University of Maine System
UMaine Audio/Visual System Design and Installation Services - RFP # 54-15
ADDENDUM #2

PROJECT NAME:
 100 D.P. CORBETT AUDITORIUM
 CONTROL SIGNAL FLOW

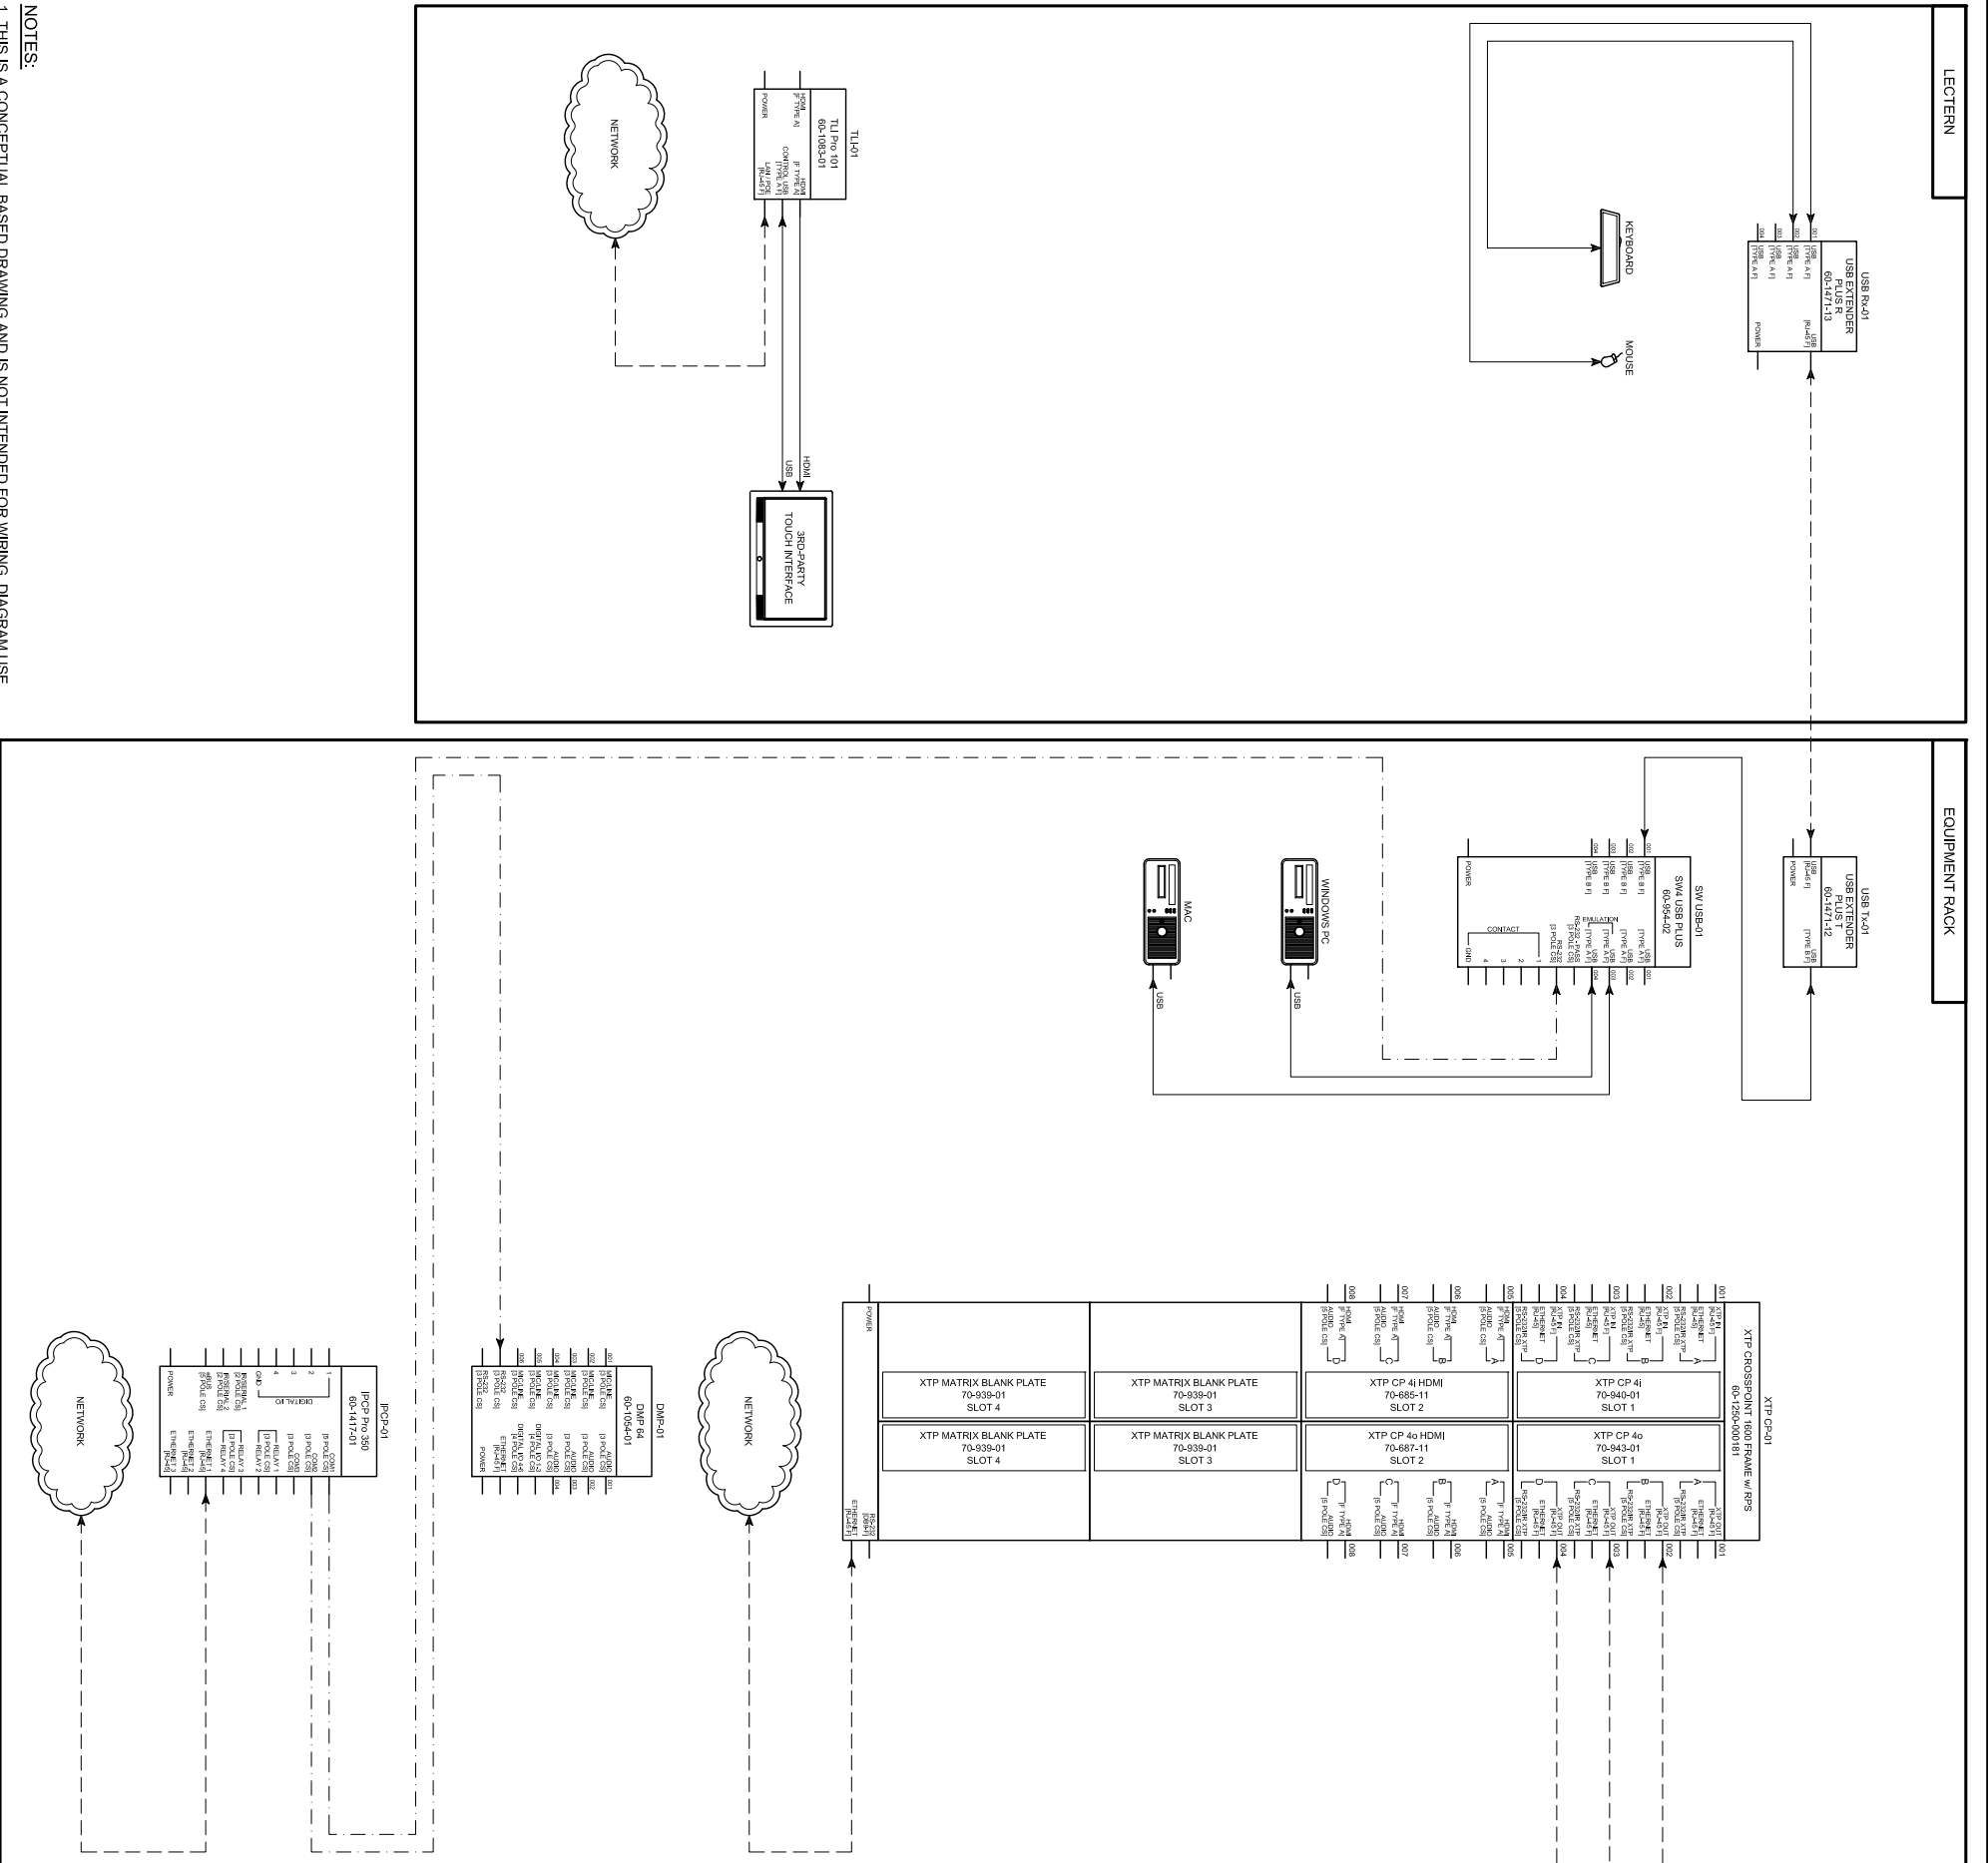
6. Is there a system line drawing that your people may have built that could be shared with the bidders?

ANSWER: 2107958-1 REV A and 2107958-2 REV A attached. Note that speaker and computer inventory is accurate per RFP and not these system line drawings.
